**AGENDA FOR REGULAR MEETING
VILLAGE OF TINLEY PARK
PLAN COMMISSION
May 21, 2015 – 7:30 P.M.
Council Chambers
Village Hall – 16250 S. Oak Park Avenue**

**BRIXMOR OUTLOT – 15917 S. HARLEM AVENUE – SITE PLAN APPROVAL
AND A SPECIAL USE FOR A SUBSTANTIAL DEVIATION TO THE TINLEY
PARK PLAZA PLANNED UNIT DEVELOPMENT**

**THE GREAT ESCAPE - 17231 LaGrange Road/9425 171st Street – SITE PLAN
APPROVAL (New Item)**

PLAN COMMISSION STAFF REPORT

Area 1

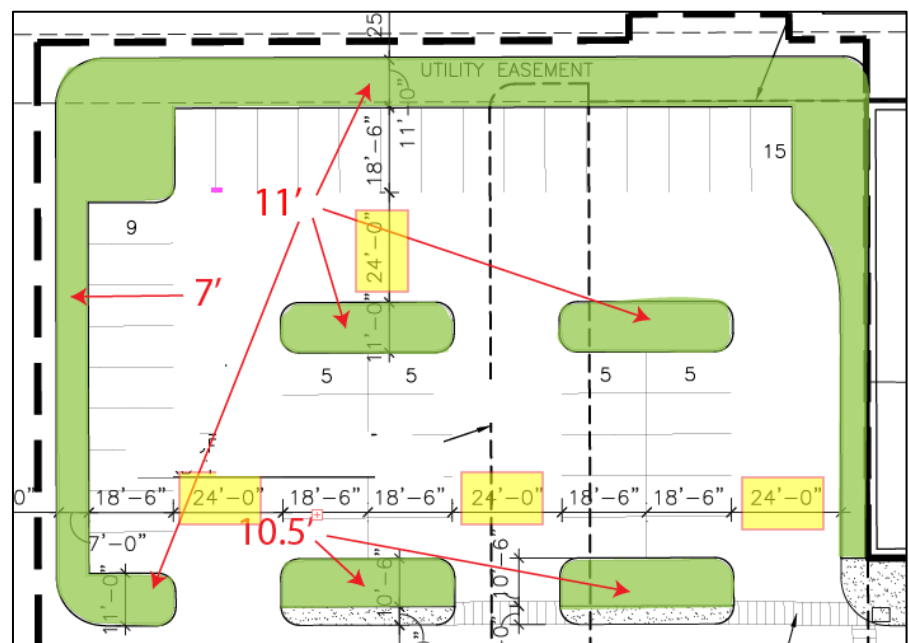
The Applicant has provided a revised plan that addresses the bufferyard, parking island width and parking lot screening concerns of the previous submittal. The east side of the parking which will function as the east bufferyard has been increased from 7' to 11', which exceeds the bufferyard minimum requirement. The four (4) landscape islands have been increased to also exceed ordinance requirements and measure 10.5' and 11' in width, thus eliminating the deficient parking island widths of the previous proposal.

The north edge of the parking will serve as the bufferyard for this property since there is limited availability north of the east-west access drive bordering this parking lot. A type 'B' bufferyard is required with a minimum width of 5'. A 7' bufferyard has been provided; this is 1' greater than the original proposal. This will provide adequate planting area especially in light of the car

overhang. The limiting dimension for this lot configuration is the north-south dimension, therefore the parking lot aisles measure 24' in width (ordinance requires 26'). Staff is supportive of this request in light of the lot configuration and the additional landscaping that has been provided to mitigate the impact of the parking field.

Area 2

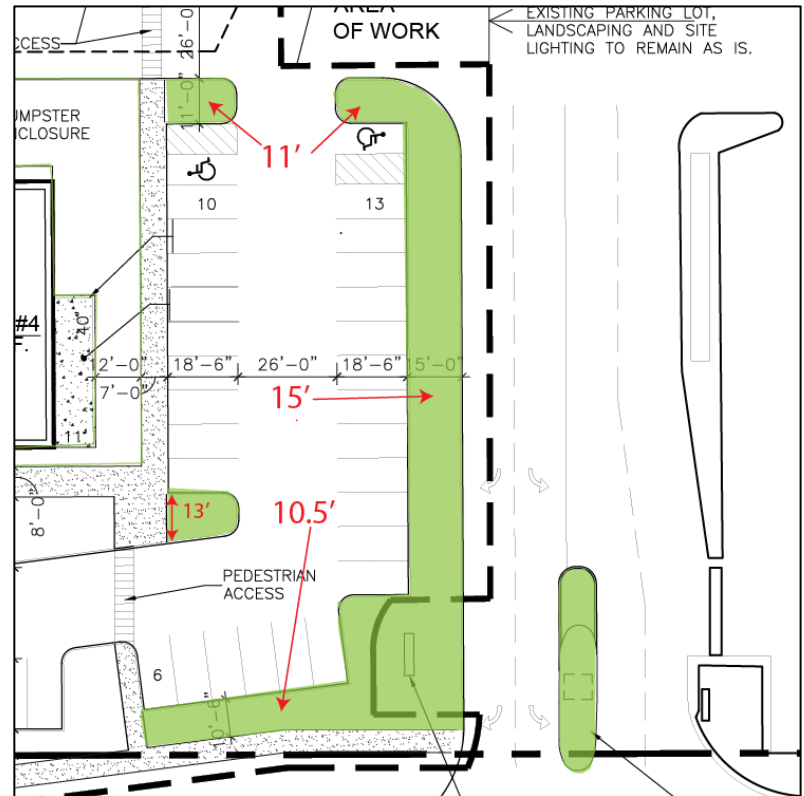
Area 2 comprises the parking field to the south of the proposed multi-tenant structure and includes the entry boulevard from Harlem Avenue. The Applicant made significant revisions to the original proposal resulting in improved circulation, decreased points of conflict with the main drive aisle, increased landscape island widths which meet aisle width requirements. No exceptions to Village ordinance are required with this new proposal.

The proposed entryway boulevard continues to provide a four lane cross section with additional width provided at the intersection with Harlem Avenue. This will provide easier and safer access to the center and additional opportunity for landscaping. The existing landscaped island has been increased by 15' in length. Currently there is an exit from this parking area located at the southwest corner of the lot (close to the intersection) which has been eliminated for the improvement of circulation and access to the center.

The six (6') foot public sidewalk required along the Harlem Street frontage has been relocated out of the public ROW at the south end of the property due to the topography and deep drainage swale. The Applicant has agreed to record a public access easement for this encroachment onto their property. The revised plan provides a 10.5 bufferyard in this area (minimum required is 10') which will provide the necessary landscaping and will easily accommodate the bumper overhang for cars parked in this area. This is a significant improvement from the original proposal.

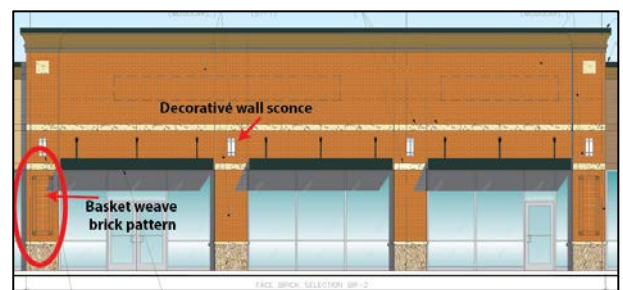
The proposed architecture provides a one-story masonry structure. As an outlot structure, the building is seen from all four sides and therefore the building architecture should present attractive, complete façades on all four elevations. While there is a recognized front entrance to the building, there should not be a recognizable rear façade to the building. The west façade will function as the primary entrance; however, the sides and rear elevations must provide equivalent architectural interest.

The Building Code requires structures of this size to be built with 75% face brick and the remainder must be built as masonry. Alternate materials, such as EFIS, are to be used only as architectural treatments. The proposed structure provides 78% brick and therefore meets masonry requirements.

The proposed architecture presents "column" corner elements on both the north and south ends of the building, on the west façade. The Applicant has worked cooperatively with Staff and has revised the original proposal to provide full parapets for the corner elements. Staff appreciates this redesign and is supportive of the architectural revisions made to the original proposal.

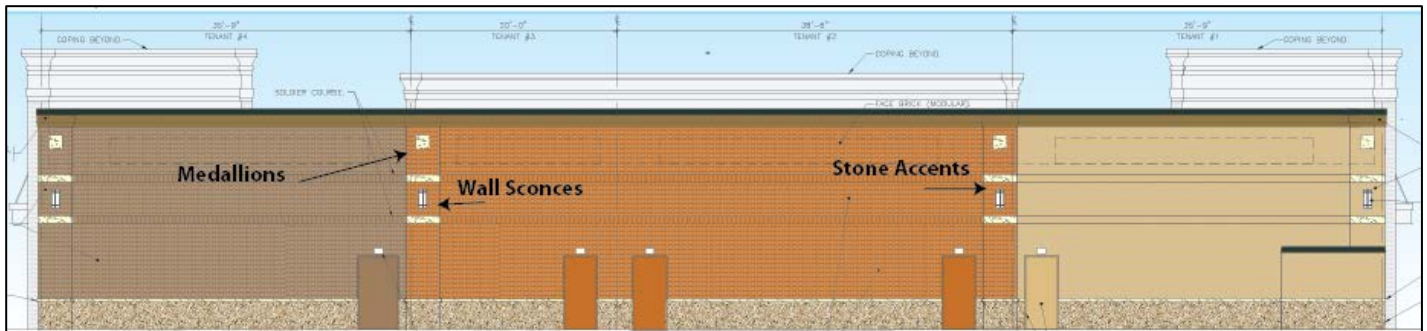
The Applicant has provided some additional architectural enhancements to the rear façade from what was originally proposed (which was lacking in architectural interest compared to the other facades). The Applicant has incorporated several of Staff's recommendations including a change in brick color that echoes the brick colors of the individual tenant spaces as seen on the west façade. A 4" reveal reflects a column element with stone accents and medallions have been added. These revisions along with the additional green space as recommended by Staff will help to mitigate the appearance of a "rear" façade.

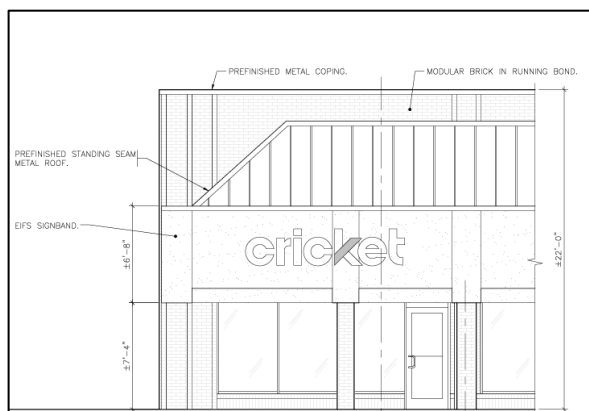
The HVAC units must be screened from public view. The Applicant has stated that the actual roof line is approximately 5' below the parapet and should completely screen the units; prefinished screens, manufactured by City Scapes, would be installed if necessary.

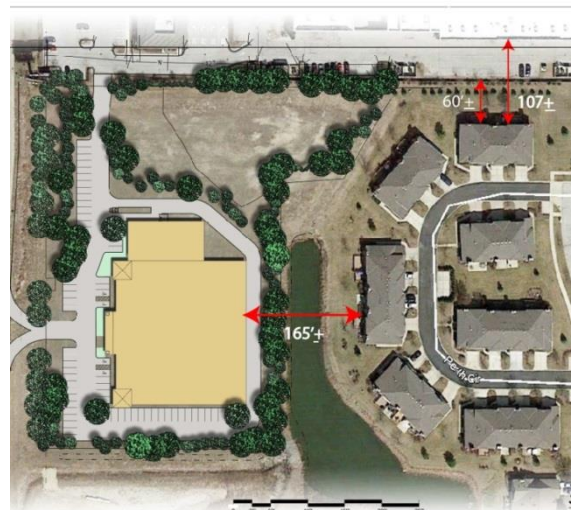
The front (west) façade is comprised almost entirely of brick (92%), with split face veneer and limestone columns flanking the entrance. Per Staff's request the Architect has reduced the amount of EFIS and increased the amount of brick in this location. The side elevations also include a significant amount of brick (71% & 76%) with the brick water table continuing along the same horizontal band as the front façade, and introduces the split face veneer for the top 5.5' to match the same banding as the front façade. The split face veneer will match the color of the EFIS on the front facade. The rear façade continues this same color banding with the brick water table at the bottom of the elevation and the split face veneer at the top of the elevation. The middle area will be colored to match the brick color on the side elevations but will be comprised of a split face veneer. The appearance will be consistent with the looks of the side elevations.

The Applicant has revised earlier proposals for Spandrel glass and is now providing true window glazing on both tower elements and all windows on the south elevation. The three windows on either side of the entry way are proposed for Spandrel glass, however only the bottom half of the window will be visible. These areas are used for display within the building. The shading from the awnings will limit the ability to determine the type of glazing on these windows.

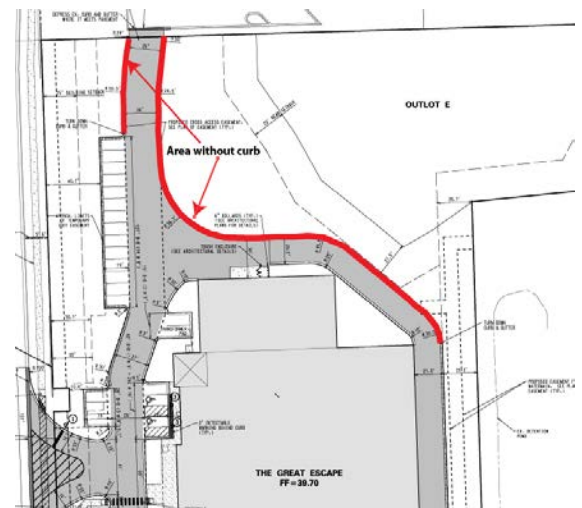
The trash receptacle will be enclosed on two sides with a 6' brick wall; the third side will be the brick exterior wall of the warehouse. The gates will be a heavy duty metal with wood facing. Details can be found on Sheet A.2.0.
